APPENDIX G CULTURAL RESOURCE CORRESPONDENCE

The U.S. Army Corps of Engineers, New York District (Corps) in partnership with NJDEP Bureau of Coastal Engineering, is proceeding with design and construction of the Port Monmouth Hurricane and Storm Damage Reduction Project in Port Monmouth, Middletown Township, Monmouth County, New Jersey (Enclosure 1). The project has three components; flood damage reduction, shoreline protection and wetland mitigation. Presently, just the shoreline protection component is moving forward (Enclosure 2).

Monmouth County, Middletown Township Port Monmouth Flood Control Project Activities at the Seabrook Wilson House

Monmouth County, Middletown Township Port Monmouth Combined Flood Control and Shore Protection Project

Attachment 3

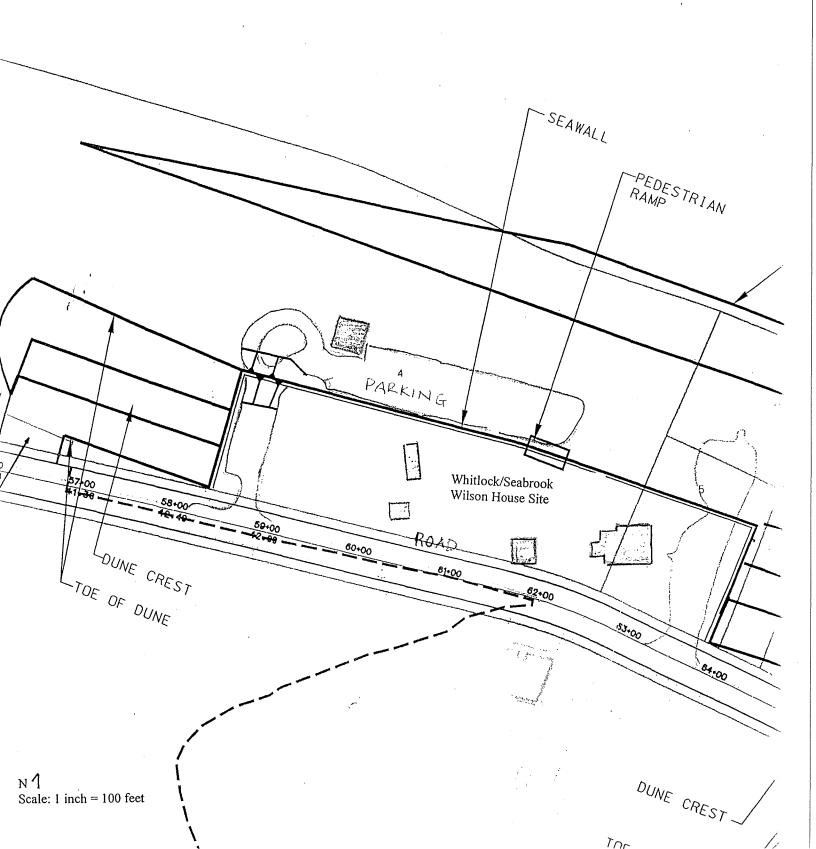
The proposed alignment of the seawall is shown in Attachment 3. Please note however, that the Corps is considering shifting the segment of the seawall that extends through the rear yard (northern section of the property) approximately 100 feet to the north. Moving the seawall's location towards the beach may minimize effects to archaeological deposits associated with the historic occupation of the house. The Corps is also considering shifting the western and eastern segments of the seawall further away from the house, actions that may further minimize effects to historic period archaeological deposits.

If the alignment shown in Attachment 3 is adopted by the Corps of Engineers, the Area of Potential Affect (APE) for the northern segment of the seawall will crosscut the backyard (or northern section) of the site, passing at some points as close as 100 feet of the house. Within such portions of the APE, located closest to the house, it is recommended that data recovery be undertaken at later phases of project planning.

I concur with your assessment that construction of the floodwall in the rear yard of the property would affect character defining features of the historic setting, and would be likely to affect contributing archaeological deposits. I encourage your plan to consider a shift of the segment of the levee and floodwall/seawall that extend through the rear yard

to a location northward beyond the yard and into the current beach zone. I also encourage your plan to consider shifting adjacent eastern and western segments further away from the house. These shifts would result in avoiding effects to contributing archaeological deposits, and minimizing visual effects to the historic setting. I encourage all reasonable efforts to avoid and minimize effects to this historic property.

Impacts on Historical Landscape. Although the landscape setting of the Seabrook Wilson House has been altered over time, a seawall across the rear yard of the house is objectionable because of adverse impacts on the historic character of the house and its remaining historic landscape. As the imminent owner of the Seabrook Wilson House, the Monmouth County Park System will be making a significant investment in the preservation and enhancement of the site in the years to come; visitors will come to not only to the see the house but also to enjoy its shoreline setting and views. A seawall across the back yard of the site would undermine these preservation objectives. The revised location of the seawall, generally along the north side of the

fishing pier parking lot, would appear to minimize adverse impacts on the historic landscape. My understanding is that the seawall is to be constructed of steel sheet piles and poured concrete encased in sand, with a footprint not to exceed 3 feet and a typical wall height of 4 to 5 feet above existing grade. In general, the sand-encased seawall, with dune stabilization plantings, should represent a naturalistic dune in its finished appearance. Also, the location of overwalks should be coordinated with the Park System's plans for use of the site and park. However, impacts on the landscape can not be fully evaluated until additional information is provided. A sectional view at the house, extending from the road to the beach, showing existing/proposed elevations and construction details of the seawall and reconstructed dune, is requested from the Corps of Engineers in order to complete this review.
